Access Compliance Report Public Rights-of-Way (Curb Ramps)

Main Street: WALNUT_AVE Cross Street: HEWES_ST Location: NW

ADA ID: RPAT210928133207 Ramp Type: Type 4 - Parallel Initial Pass/Fail: Pass Overall Compliance: No Severity Score: 0

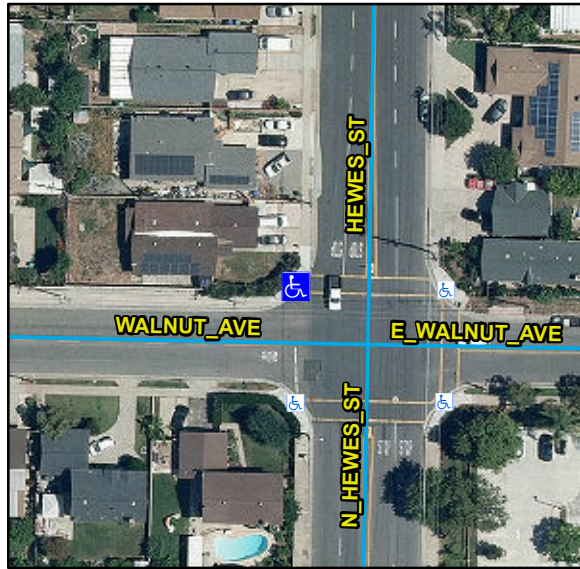
Crossing 1 Slope (%)	2.3		Crossing 2 Slope (%)	4.5
	Crossing 1 Cross Slope (%)	4.1		Crossing 2 Cross Slope (%)	2.2
Yes	Gutter Ponding	No	No	Curb Slope	11.2
Yes	Gutter Lip Height (in)	0		Road Run Slope (%)	2.2
Yes	Gutter Run Slope (%)	4.7		Road Cross Slope (%)	3.1
Yes	Gutter Cross Slope (%)	0.8	Yes	Perpendicular Joint Present	Yes
Yes	Overall Surface Condition	Acceptable			
	Cross Gutter Present?	No		Spandrel Present?	No
	Replace Cross Gutter?	N/A		Replace Spandrel?	N/A

Remove & Replace Curb Slope. Restripe Crosswalk.

R304.2.2, R207.1, STD 1115
